LCAN1/0-14-X
Copper Lug - One-Hole, Narrow Tongue, Standard Barrel

LCAN1_0-14-CUST

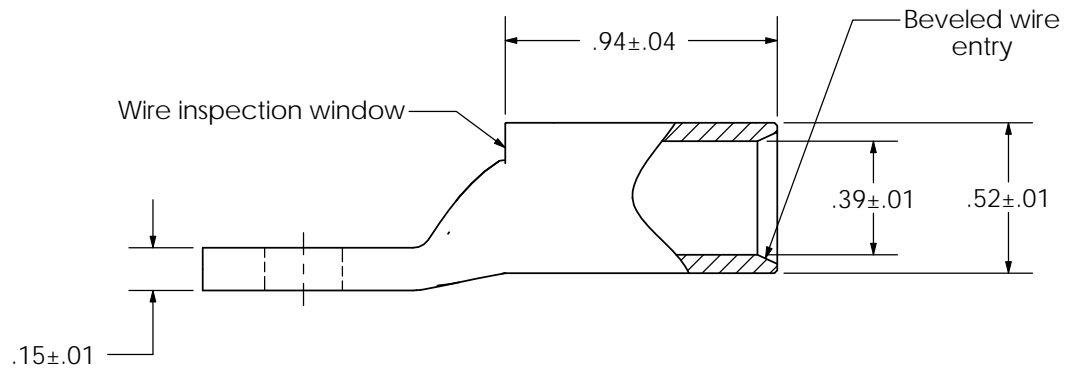
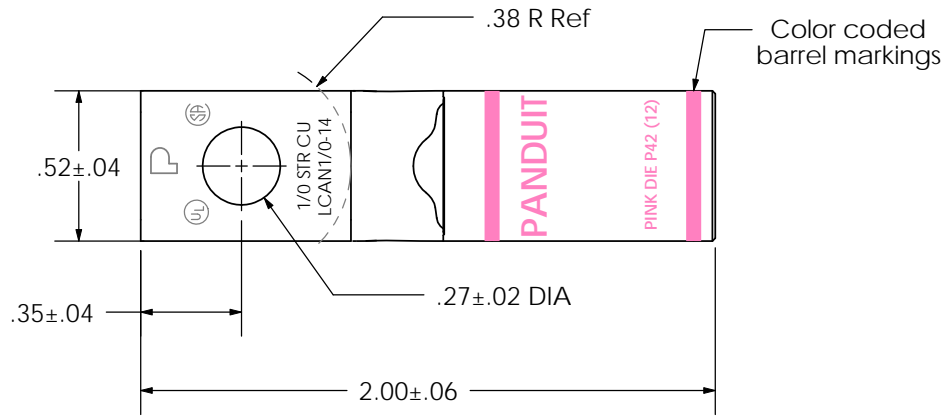
REV	DATE	BY	CHK	DESCRIPTION	ECN	SCALE	DRAWING NO / CAD FILE
02	1/11	JHNU	JHNU	REVISED OVERALL LENGTH: WAS 1.97 REVISED HOLE OFFSET: WAS .32		N/A	LCAN1_0-14-CUST
